Subject: Responses to Requests for Additional Information on 6002-00301, CS Innovations' "Advanced Logic System Topical Report"

**Responses to Requests for Additional Information (RAIs) on 6002-00301, CS Innovations’
“Advanced Logic System Topical Report”
(IC-11-106)**

Subject: Responses to Requests for Additional Information (RAIs) on
the Advanced Logic System Topical Report, Document 6002-00301

Figure 6.1 Temperature Versus Humidity - Enclosed Environments Outside Containment

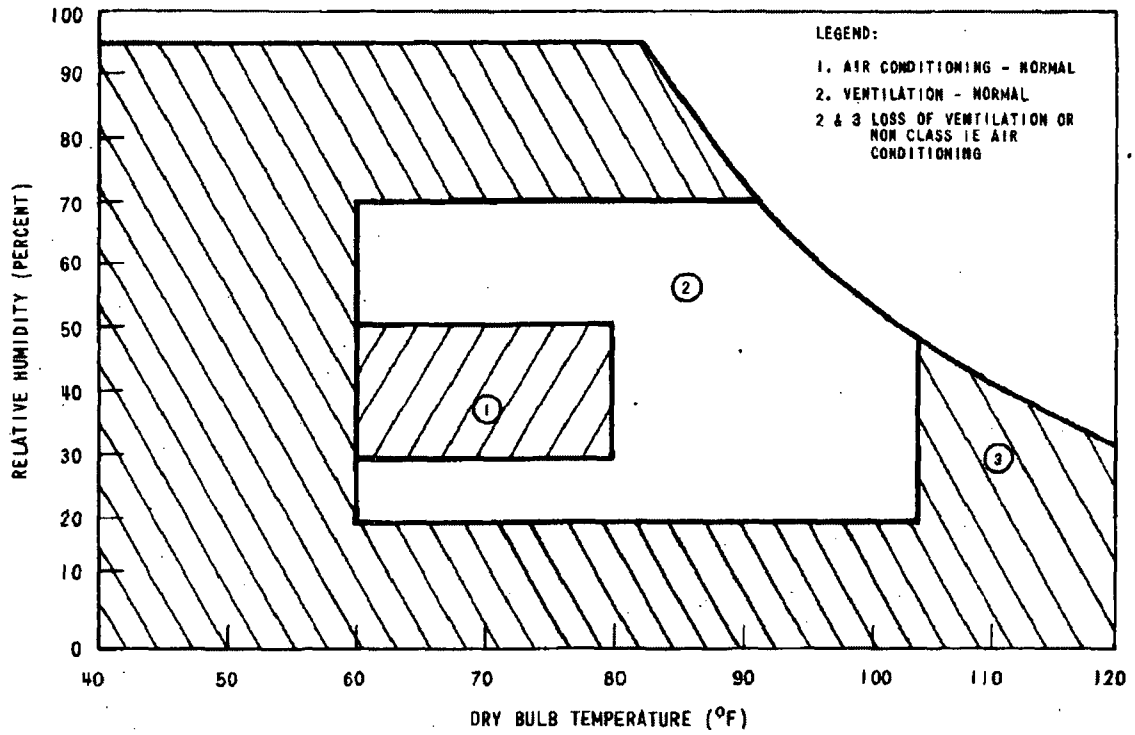
Describe how the combination of environmental conditions that are represented in the environmental profile of Advanced Logic System (ALS) EQ Plan (Section 5) and the ALS Topical Report (Section 4.1.1) and the limits identified in ALS Topical Report and the ALS Platform Requirements Specification (Section 9.1) sufficiently envelope the ALS Platform's susceptibility to synergistic effects from the proposed service conditions. This description should address Regulatory Guide 1.209 Regulatory Position 1 and Digital I&C-ISG-06 Section D.5.4.1.

The ALS Platform follows the standard Westinghouse Equipment Qualification methodology for qualifying safety grade equipment as documented in the NRC approved WCAP-8587, revision 6-A. The postulated worst case abnormal temperature and humidity conditions are based on Table 6-1 (reproduced below) for equipment located outside of containment in mild environments. Figure 6-1 (reproduced below) also illustrates the abnormal temperature and humidity conditions. As required by Regulatory Guide 1.209, the test conditions will simulate the actual abnormal environments and durations given in the Table.

To address synergistic affects, the environmental conditions of temperature, humidity, voltage and frequency are applied simultaneously to the equipment under test. Performance of the equipment and its ability to perform its safety function are demonstrated under these extremes. Any additional synergistic effects resulting from future service conditions will have to be evaluated when they are made available.

Qualification is performed to envelop the anticipated operating environments. The environmental requirements in the ALS Platform Requirement Specification are not the basis used to develop environmental qualification testing profiles.
